UNITED STATES PATENT AND TRADEMARK OFFICE

APPLICATION NO.	FILING DATE	FIRST NAMED INVENTOR	ATTORNEY DOCKET NO.	CONFIRMATION NO.
10/530,872	02/28/2006	Anne Elliot Merica	033670-007	4501
21839 7590 03/18/2009 BUCHANAN, INGERSOLL & ROONEY PC POST OFFICE BOX 1404 ALEXANDRIA, VA 22313-1404				
EXAMINER CHAPMAN, JEANETTE E				
ART UNIT 3633		PAPER NUMBER		
NOTIFICATION DATE 03/18/2009		DELIVERY MODE ELECTRONIC

Office Action Summary

claim 5.

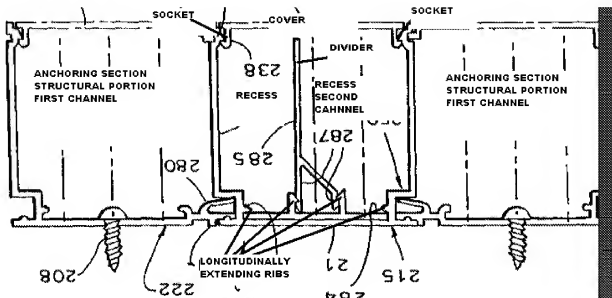
Biebuyck discloses a cover on the structural portion having longitudinally extending marginal edges defined so as to fit longitudinally extending sockets and 48/30 provided for this purpose in opposed wall sections 216 of said sill wherein one of said sockets 30 defines a pivot of said cover. It would have been obvious to provide the cover socket configuration on the recess to provide a pivotable cover as shown by the base reference.
